Re: Power the South Bay Project (Application 24-05-014)
Request for Minor Project Refinement No. 2

ATTACHMENT A
MPR-2 Form

Power the South Bay Project
CPUC Minor Project Refinement Form

POWER THE SOUTH BAY PROJECT
MPR-2 Vault 13
City of San Jose, CA

ATTACHMENT B
MPR-2 Figure

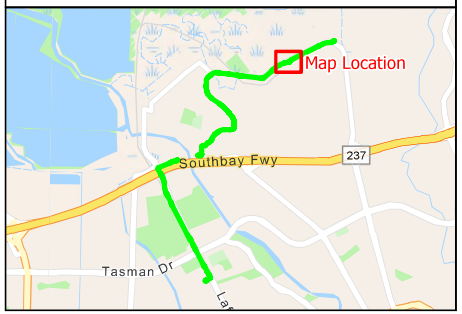
LS Power Grid California, LLC (LSPGC) is requesting approval of MPR-2 for the relocation of Vault 13 adjacent to the limits of construction approved within the Project's Final Environmental Impact Report (FEIR). It is necessary to relocate Vault 13 outside of the Los Esteros Road right-of-way (ROW) due to conflict with existing underground utilities. Vault 13 will be located approximately 20 feet south of the Los Esteros Road shoulder, on City property that contains the San Jose-Santa Clara Regional Wastewater Treatment Facility (RWF), although a portion of the MPR-2 work area and associated transmission line will remain within the Los Esteros Road ROW as described below and shown in **Attachment B, MPR-2 Figure**. Temporary use of the remaining 0.75-acre MPR-2 work area will be required as a temporary work area for temporary equipment and materials laydown and overland travel access during vault and transmission line installation activities. The MPR-2 work area within the RWF treatment facility appears to be

subject to routine discing, mowing, or other types of vegetation management activities. No ground disturbance is proposed outside of trenching for the transmission line and vault installation as shown in **Attachment B, MPR-2 Figure**. Construction of Vault 13 will require the removal of approximately four street trees from within the MPR-2 work area (i.e., City property), but would be limited to the extent practicable. All removal of street trees would be coordinated with the City of San Jose. The portion of chain-link fencing that runs along the RWF property line within the MPR-2 work area will be removed in order to install Vault 13 and associated transmission line, but will be replaced following completion of MPR-2 construction activities.

Implementation of MPR-2 would expand the Project's limit of disturbance by approximately 1.0 acre. Vault 13 would be constructed of prefabricated (precast) or cast-in-place, steel-reinforced concrete. The vault will have two manhole covers measuring approximately 39 inches in diameter. The vault would be delivered to the construction site utilizing a large flatbed semi-truck/trailer. Installation of the vault will entail excavation, shoring, and leveling of the splice vault pit using crushed gravel or flowable fill; followed by delivery and installation of the vault using a crane; filling, grouting, and compacting the backfill; and repaving the excavated area. Backfill for splice vaults would consist of flowable concrete backfill.

The MPR-2 work area would be accessed via Los Esteros Road as well as a paved access road within the RWF treatment facility. Ornamental vegetation would be removed, as needed, within the MPR-2 work area. See **Attachment B, MPR-2 Figure** for the location of the MPR-2 components.

Original Condition: Vault 13 was originally planned to be located entirely within the Los Esteros Road ROW. This portion of Los Esteros Road is paved with one lane of travel in each direction. Conditions within the MPR-2 work area were documented with the FEIR. The MPR-2 area consists of maintained landscape covered by bare ground, non-native grasses, and street trees. Supplemental resource surveys were conducted to verify current conditions as described in the Resources section below. The MPR-2 work area is located within a disturbed, mostly flat area with no native habitat or sensitive aquatic features. Although the MPR-2 work area was not identified for Project use within the Project's FEIR, it is in close proximity to approved Project components and is therefore within the geographic study area analyzed within the FEIR. Further description of current conditions within the MPR-2 work area is provided in the resource discussions herein.

Justification for Change: It is stated in Section 2.8.6.1 of the FEIR that approximately 20 to 30 vaults would be required. Vaults are located along the segments of underground transmission line, generally directly in line with the transmission line alignment. Vault 13 was originally intended to be located within the Los Esteros Road ROW. However, it is necessary to relocate Vault 13 outside of the Los Esteros Road ROW due to conflict with existing underground utilities.

Maps & Figures: Refer to **Attachment B, MPR-2 Figure,** for a map of the proposed relocated Vault 13 and work area. Refer to **Attachment C, MPR-2 Photograph Log**, for pictures of the current conditions within the MPR-2 work area.
